# SECQ Test Method and Calibration Improvements

January 17, 2018

In support of comments 82-84

# Examples: 53Gbd PAM4 SRS Conformance Signals

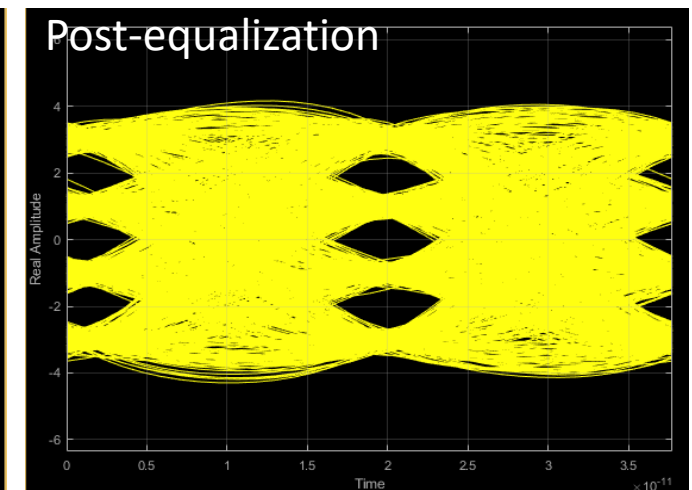
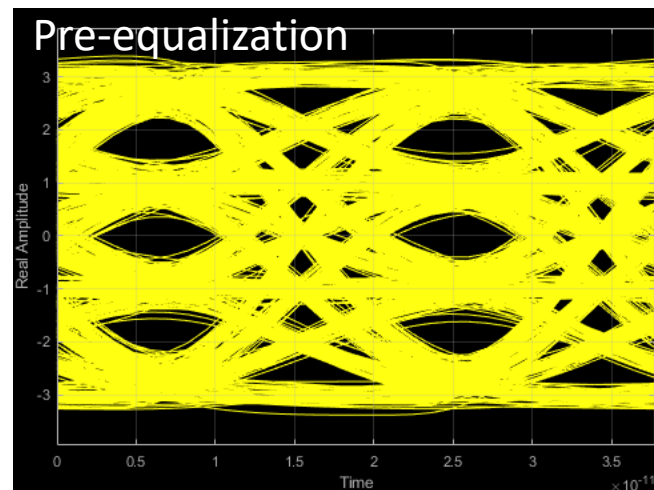
- Calibrating ISI-based “first 50%” of SECQ in accordance with draft standard gives two very different SRS conformance test waveforms
- Issue will be magnified when including allowed variance in remaining GN + SI SECQ stressors

Case A SRS conformance signal  
@ 1.7 dB SECQ  
35 dB SNR, ~22 GHz Tx BW

Case B SRS conformance signal  
@ 1.7 dB SECQ  
23.5 dB SNR, ~35 GHz Tx BW

# Proposed Remedy / Clarifying Language

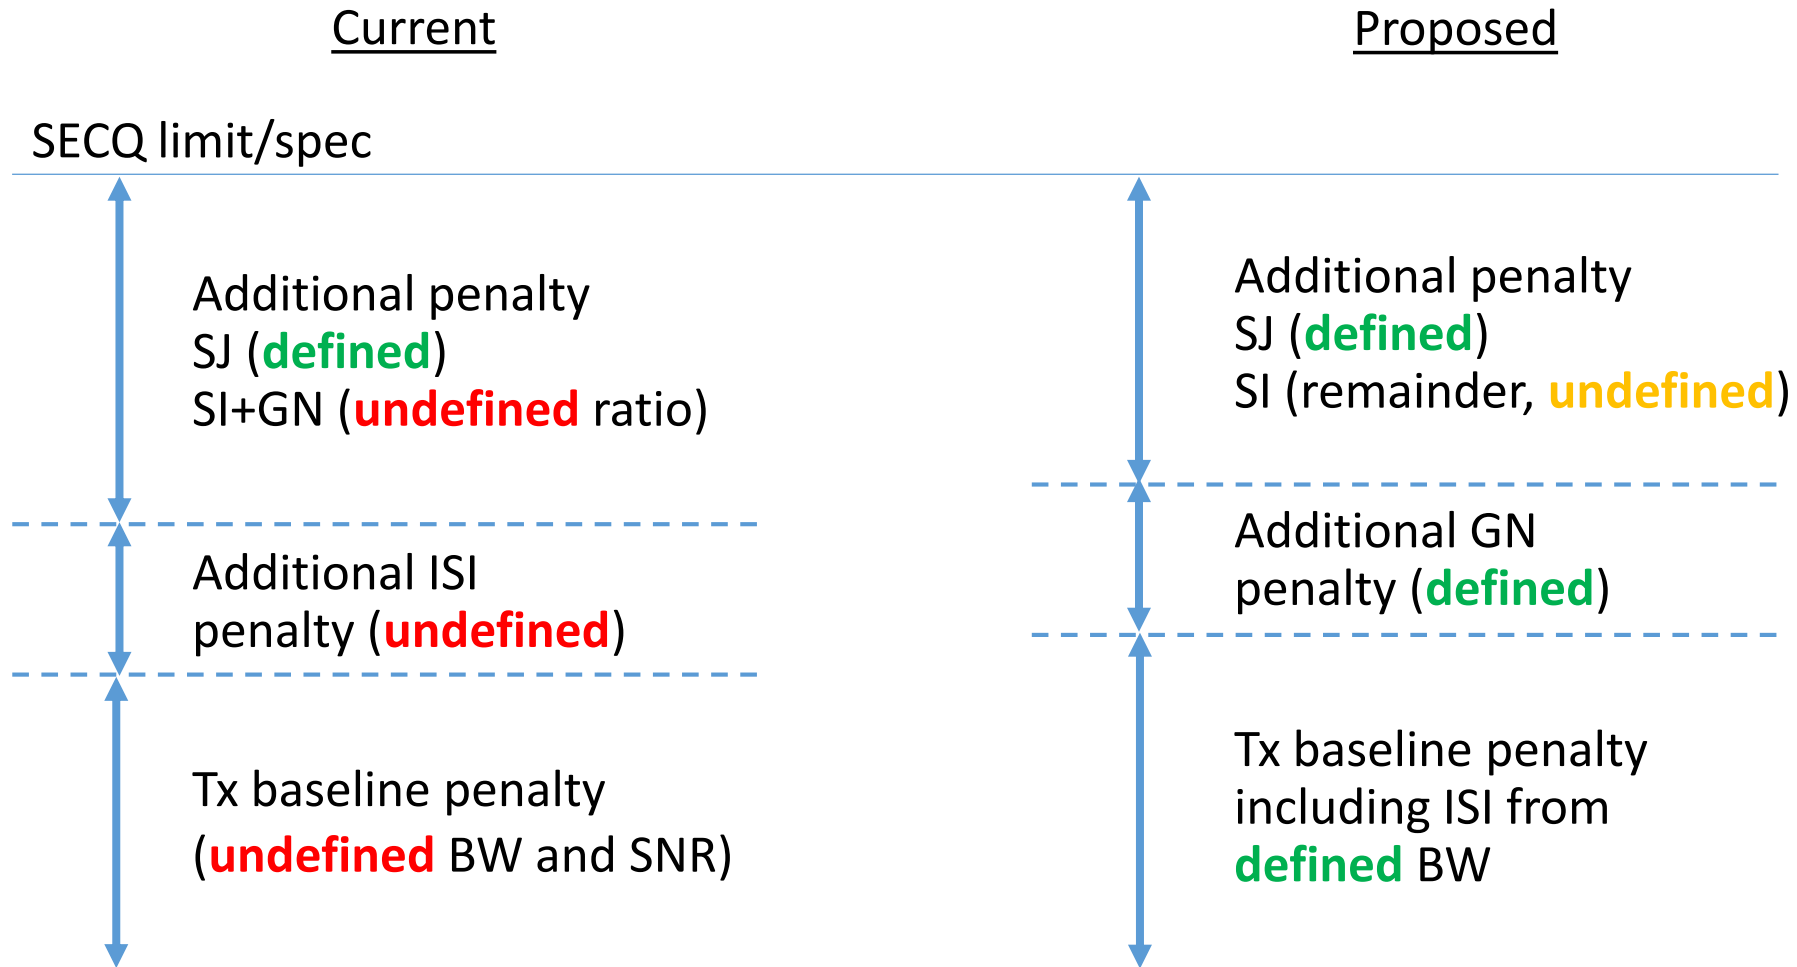
- Fix all degrees of freedom for SECQ composition except one, to get as repeatable and consistent an SRS conformance test signal as possible, rather than let everything float
- Ensure that as much as possible, various stress amounts track with actual expected values

- Specify a Tx bandwidth (13.25G for 50G/lane PAM4, 26.5G for 100G/lane PAM4) in place of the 50% ISI requirement
- Define a specific value for Gaussian noise to be added beyond baseline reference Tx + ISI SECQ (value in process, aim to tie this back to Tx with worst-case RIN value)
- Remaining SECQ comprised of sinusoidal interference and sinusoidal jitter (already defined separately)

- Remove ambiguity and variability of current “at least 50% ISI” guideline (no cap on max amt of ISI as % of total, actual ISI stress varies depending on baseline Tx SECQ, etc.), while not significantly changing the amount of ISI stress
- Remove ambiguity and variability of current “amount of your choice” language on Gaussian noise to avoid overstressing or understressing receiver, with amount tied back to actual random noise and RIN coming from Tx
- Keep the overall SECQ value unchanged

## Compare Two Cases with PRBS31Q

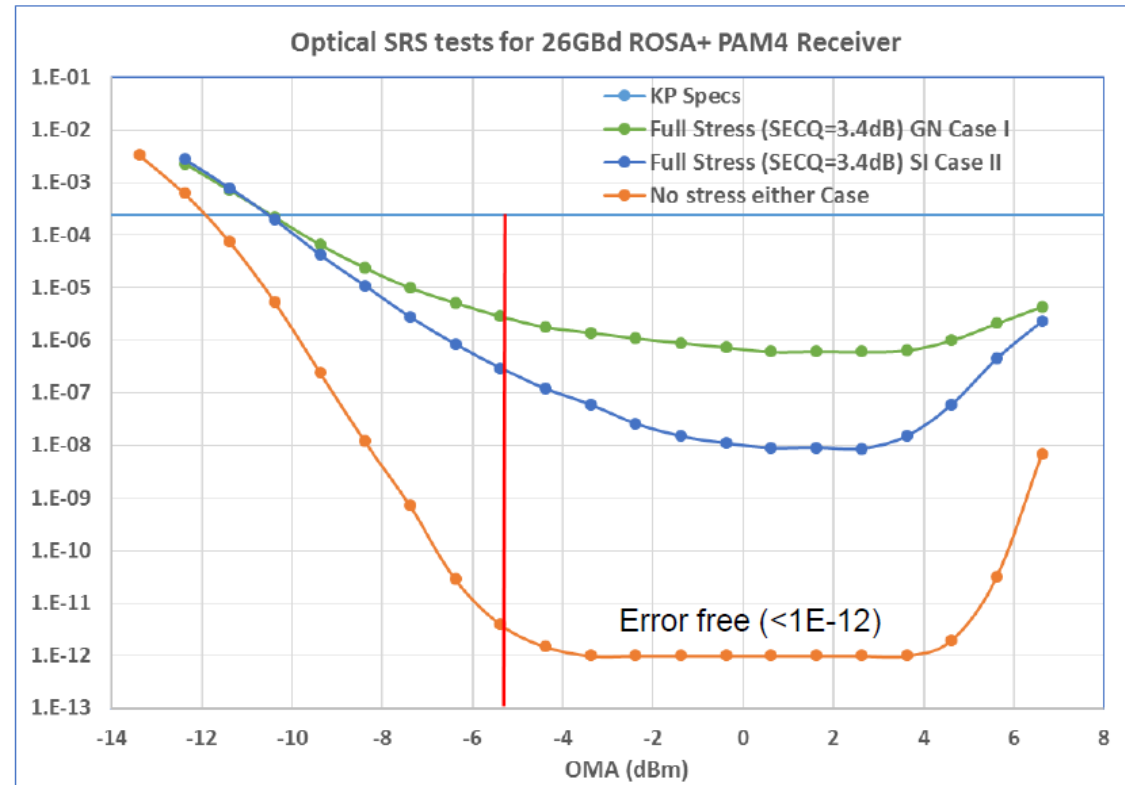
- Excerpt from chang\_3cd\_01\_1117 showing performance variation with varying SI/GN stressor ratios at same SECQ
- Note that this is for 50G PAM4; 100G PAM4 will have considerably less BER margin to FEC limit

- Same SECQ=3.4dB but with different BER behavior
